ARCHITECTURAL REVIEW COMMITTEE MEMORANDUM

SUBJECT: A REQUEST BY MDESIGN GROUP, INC., ON BEHALF OF BRANDON RIKER, FOR A MINOR ARCHITECTURAL APPLICATION TO CONSTRUCT A 609-SQUARE-FOOT DETACHED ACCESSORY STRUCTURE AND A TERRACE AT AN EXISTING HILLSIDE SINGLE-FAMILY RESIDENTIAL PROPERTY LOCATED AT 1655 RIDGEMORE DRIVE (APN: 686-412-003), ZONE R-1-C, SECTION 1 (CASE AR-2023-0073). (NK)

Case AR-2023-0073
1655 Ridgemore Drive
(APN: 686-412-003)

SITE PLAN SCALE 3/32" = 1'-0" 1

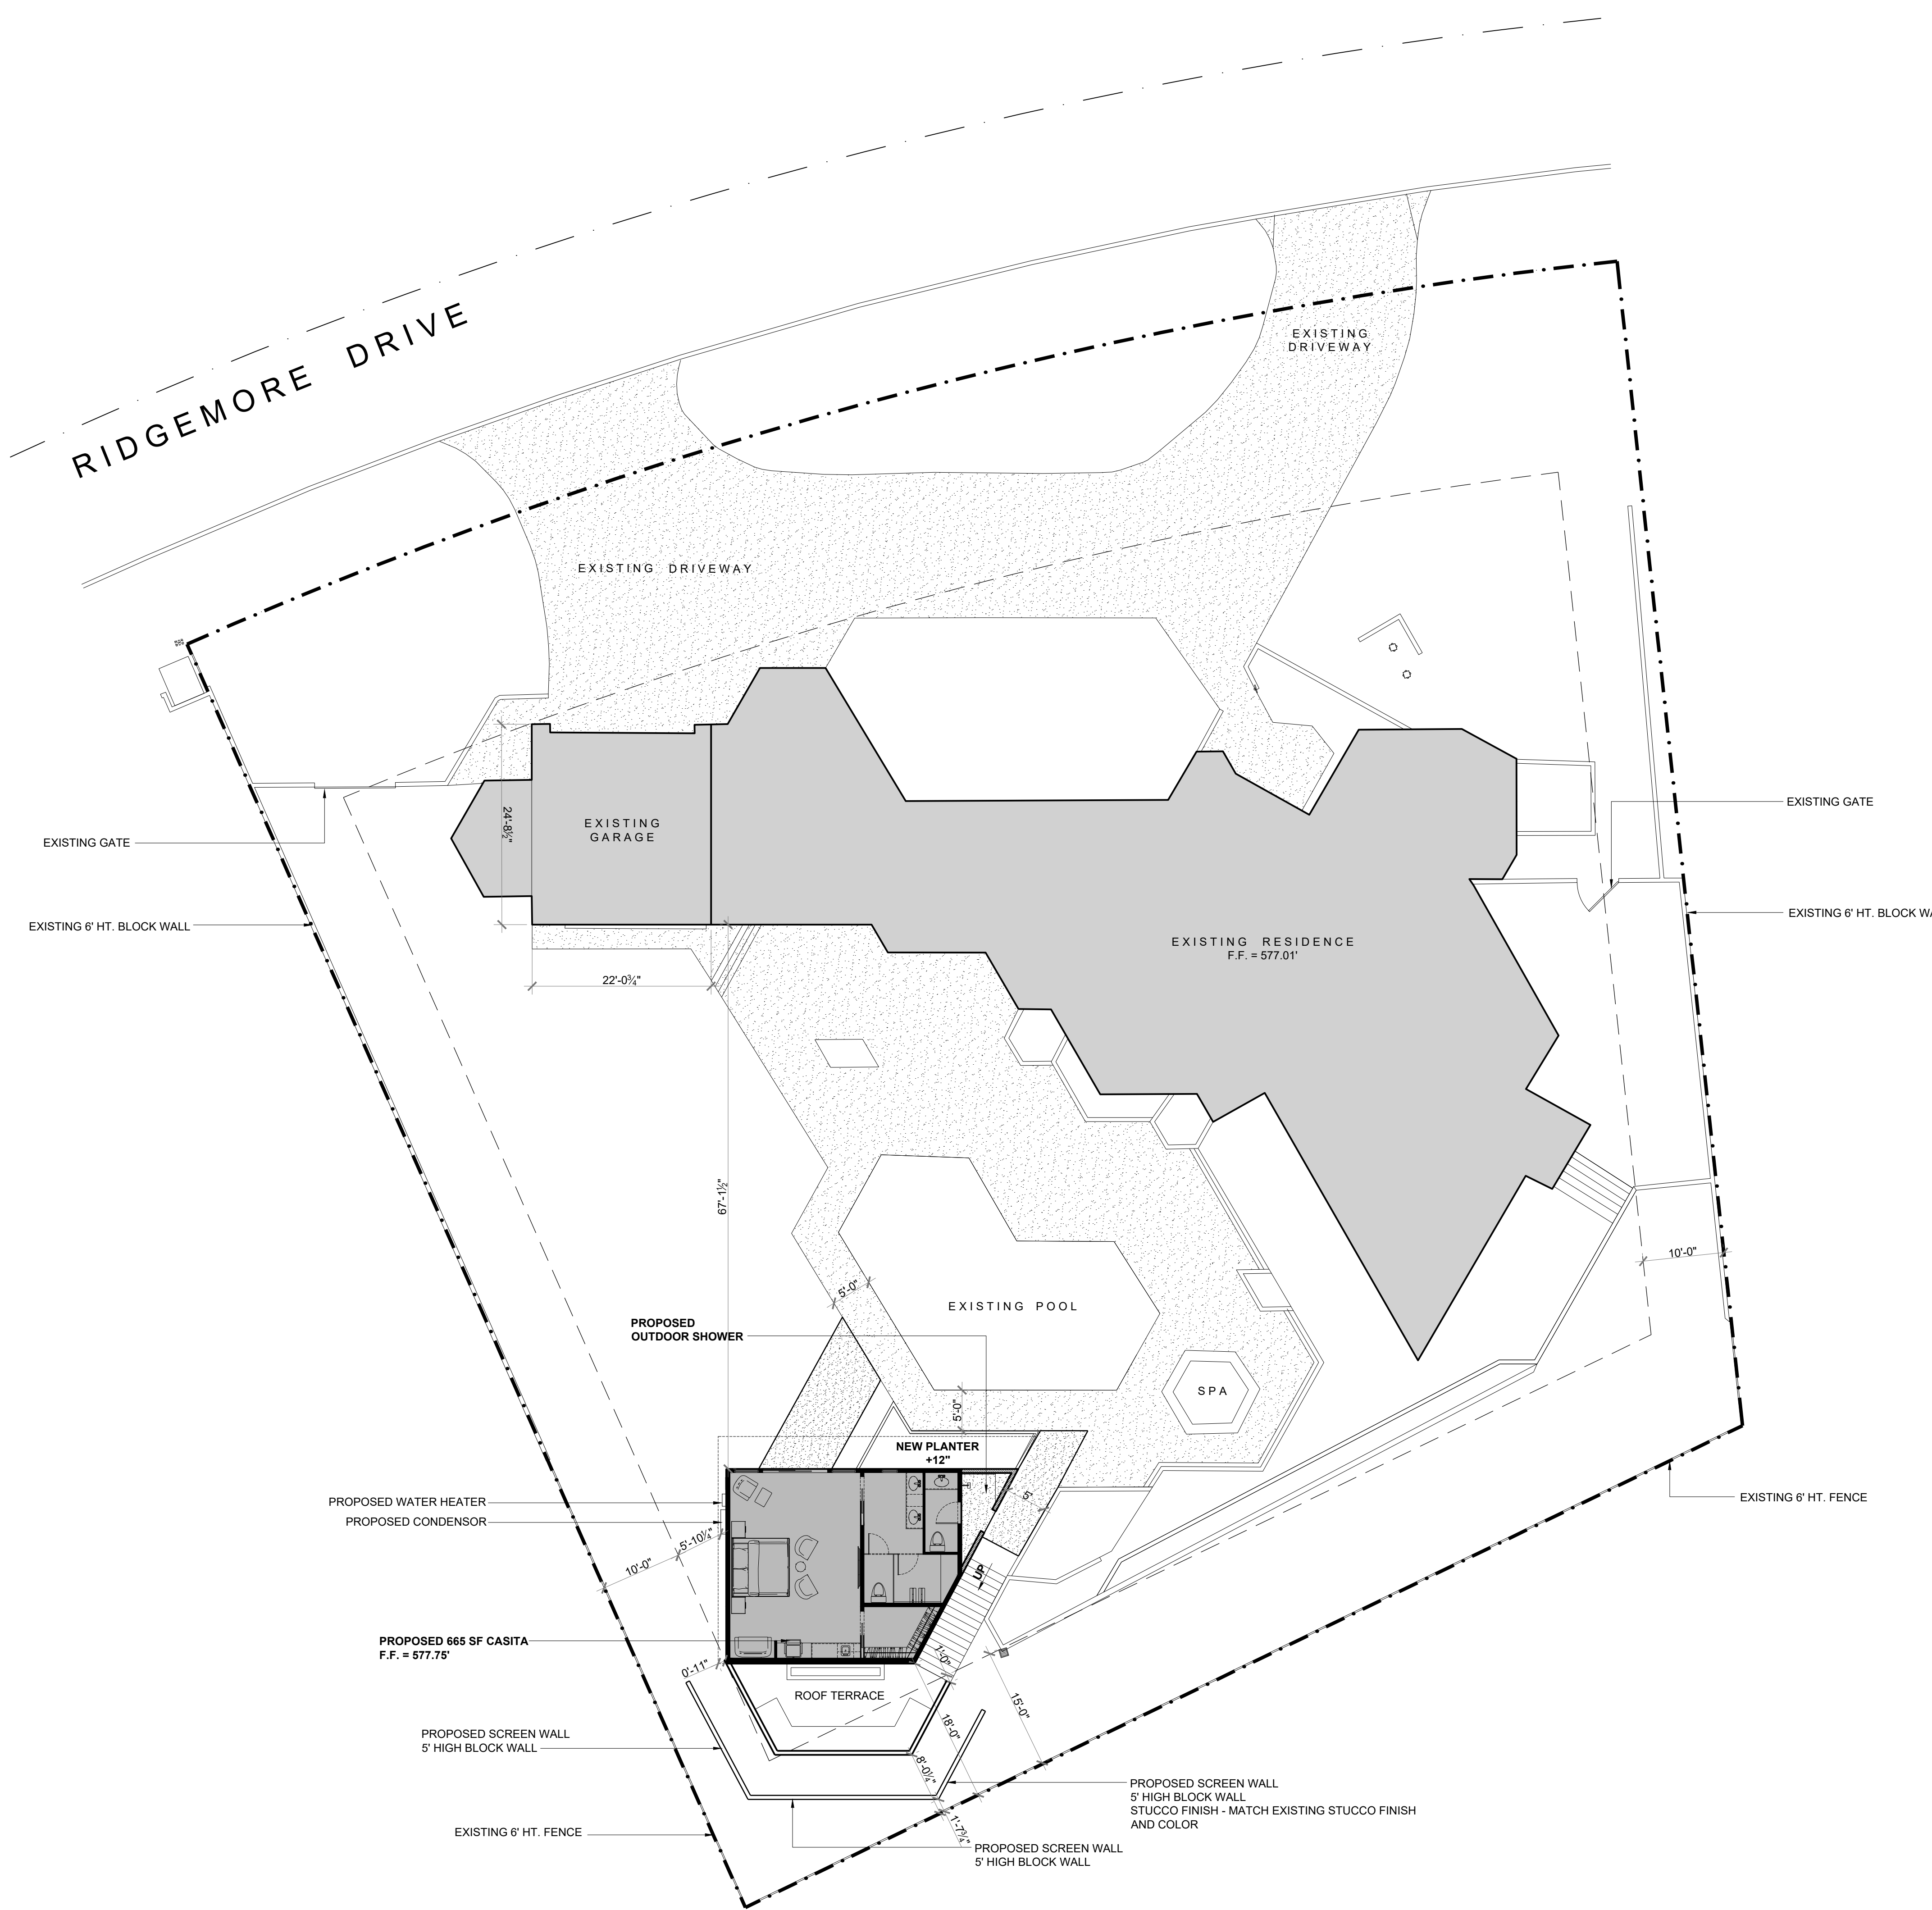
<i>Table 1. Development Standards</i>			
<i>Standard</i>	<i>Required/Allowed</i>	<i>Provided</i>	<i>Compliance</i>
Min. Setbacks			
• Front (North)	25 Feet	>25 Feet	Y
• Side (West)	10 Feet	10 Feet*	Y*
		*Excludes architectural projection	*Excludes architectural projection
• Side (East)	10 Feet	>10 Feet	Y

<i>Table 1. Development Standards</i>			
<i>Standard</i>	<i>Required/ Allowed</i>	<i>Provided</i>	<i>Compliance</i>
•Rear (South)	15 Feet	18 Feet	Y
Architectural Projection (West Elevation – Roof Overhang)	40 Inches	11 Inches	Y
Max. Lot Coverage	35%	20.0%	Y
Max. Building Height	12 Feet	10.61 Feet	Y
Building Separation	10 Feet	>10 Feet	Y
Wall/Sound Barrier Height	Max. 6 Feet	5 Feet	Y
Parking	2 spaces (covered)	2 spaces	Y

(NORTH) FRONT ELEVATION SCALE 1/4" = 1'-0" 1

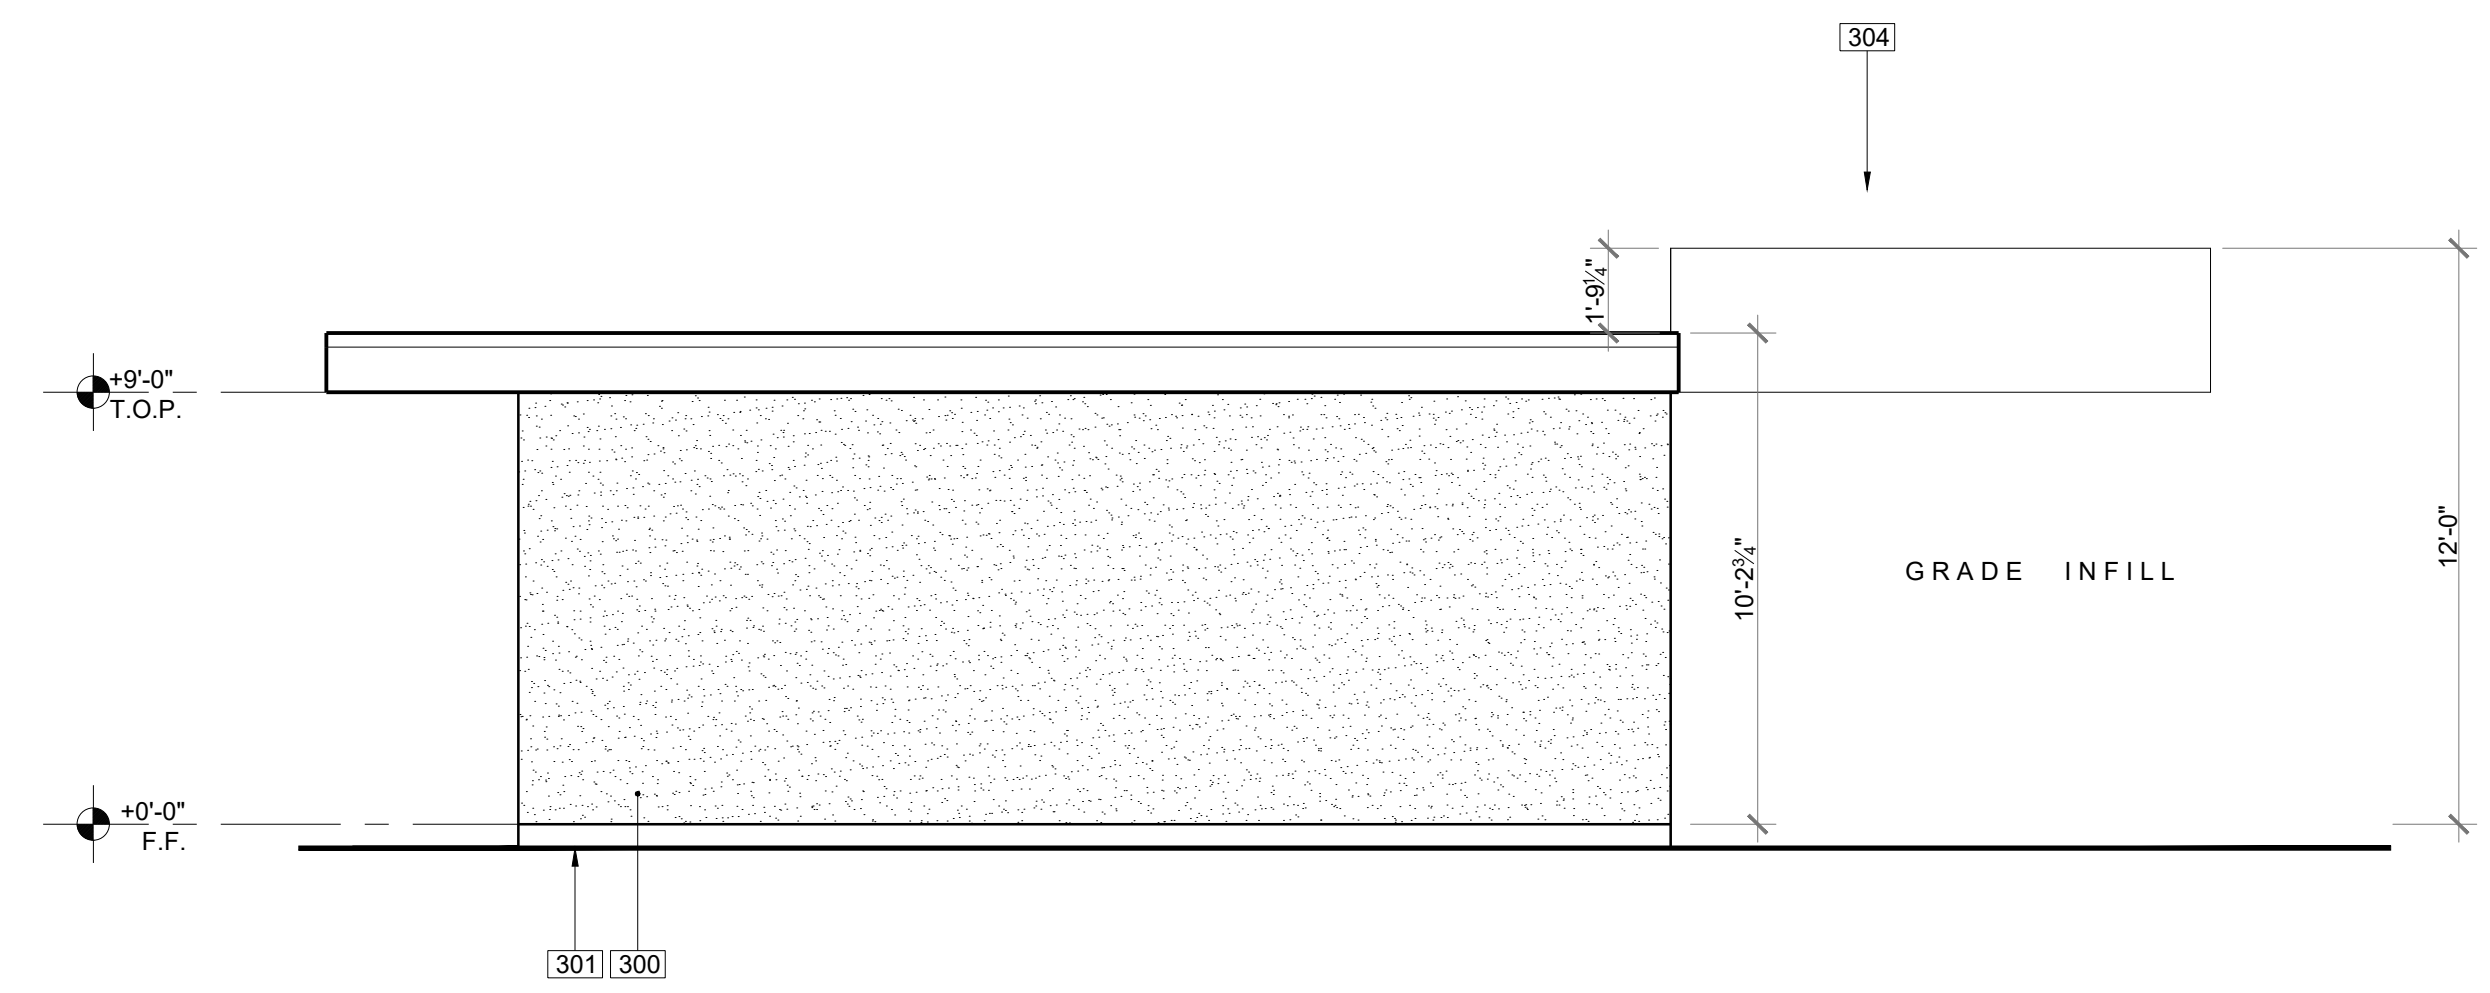
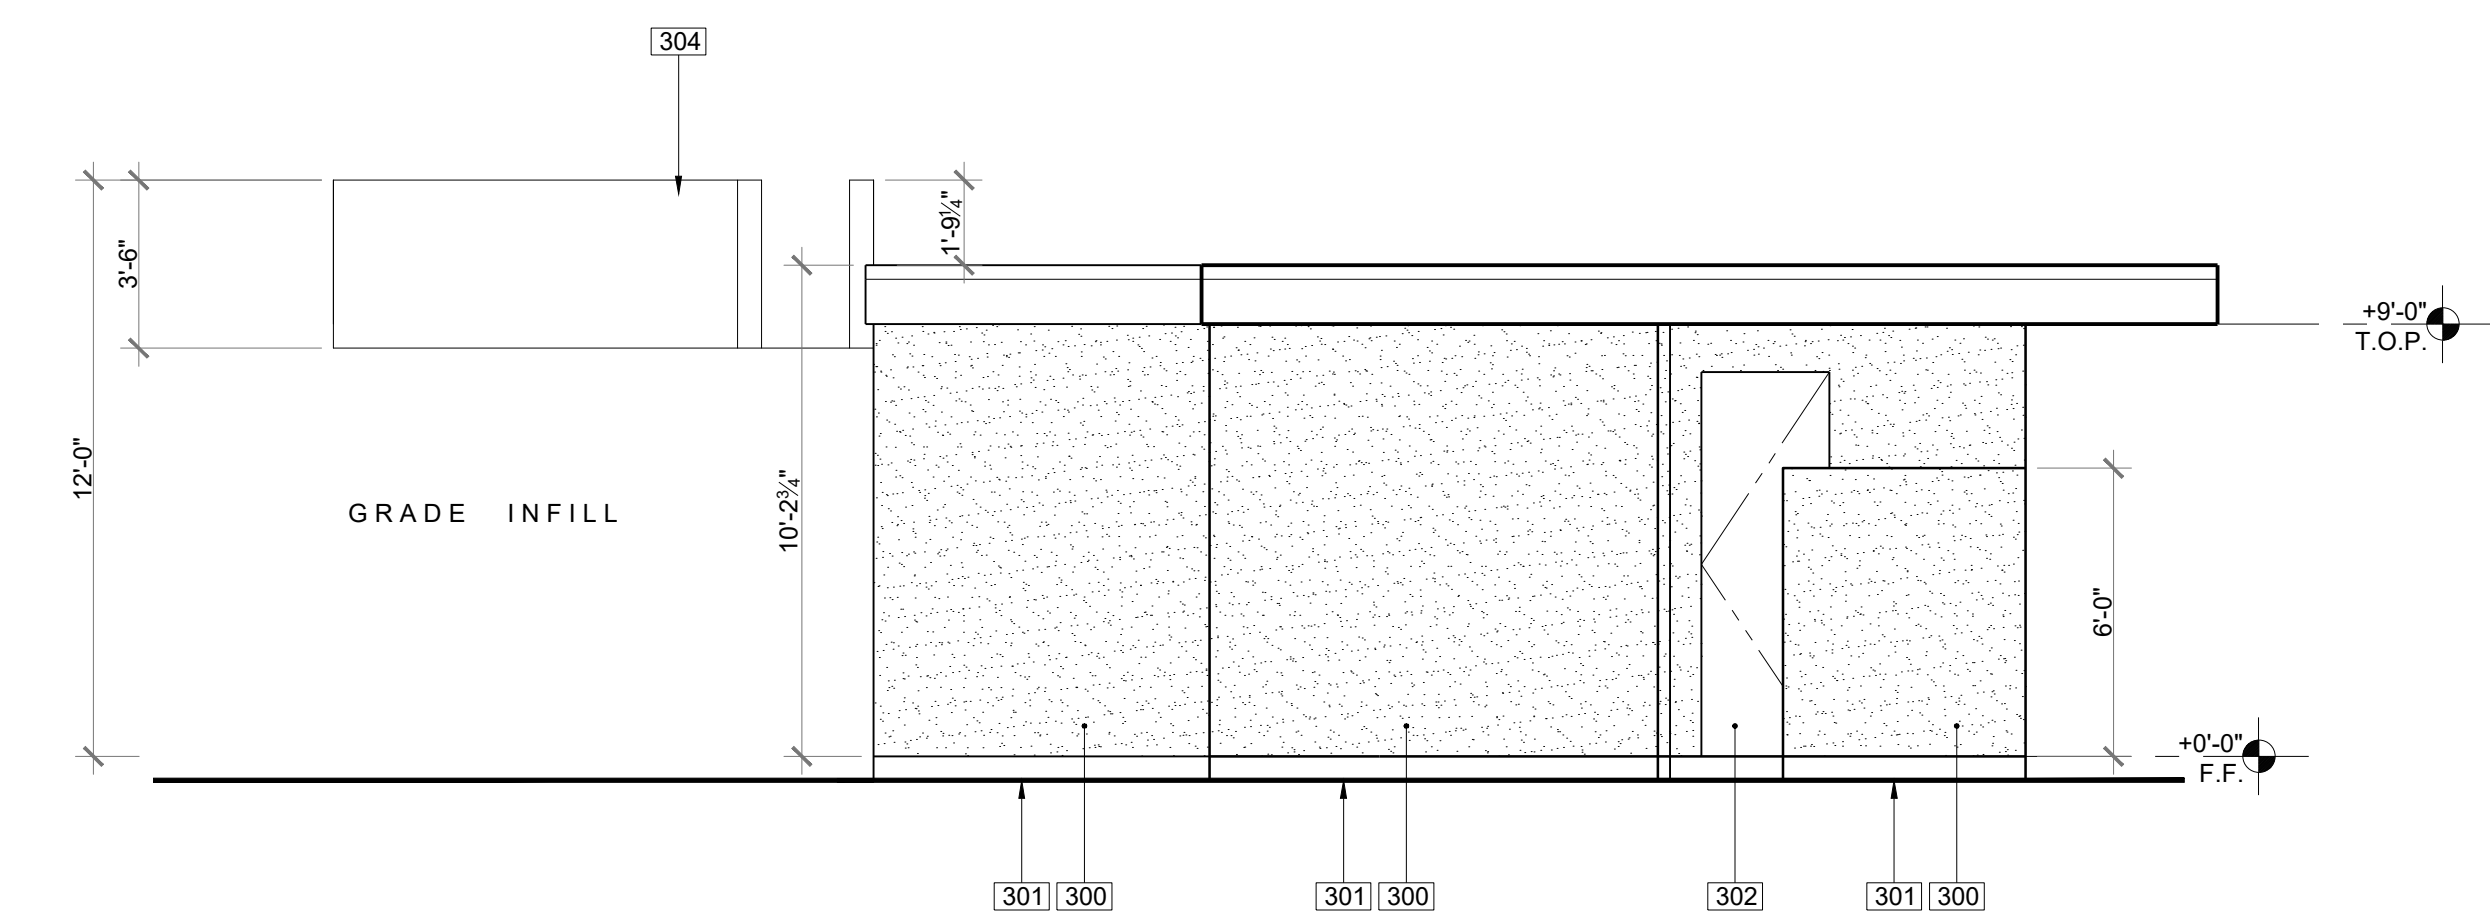
3.	<i>The façade elements and fenestration are composed in a harmonious manner;</i> Glazing is proposed for the north/primary elevation only. Since the proposed exterior design lacks any decorative elements, the windows and sliding door will function as an architectural accent on the north elevation. The new windows and sliding door will be aligned towards the west end of the north elevation to provide a blank space on the east side of the glazing. The architectural treatment of the north elevation complements the simplistic architectural treatment of the west and east elevations.	Y

5.	<i>The proposed color scheme is appropriate to the desert environment and consistent with the site context;</i> The project proposes the use of two paint colors: Total Recall (DEW312) and Serene Thought (DE6234) by Dunn-Edwards. Although the proposed paint colors for the accessory structure do not exactly match the colors found on the primary residence, they are desert neutral colors and compatible amongst each other. Being located near the southwest corner of the property in the back, the visibility of the accessory structure from the street will be limited.	Y

6.	<i>Shading devices and sun control elements, excluding landscape materials, are provided to address environmental conditions and solar orientation;</i> Glazing is proposed for the north elevation only under a roof overhang. The south elevation will function as a retaining wall for the terrace, and there will be no windows or doors proposed for the west elevation. Additionally, the east elevation will accommodate one door only. Solar control is not a concern due to the location and design of the accessory structure.	Y
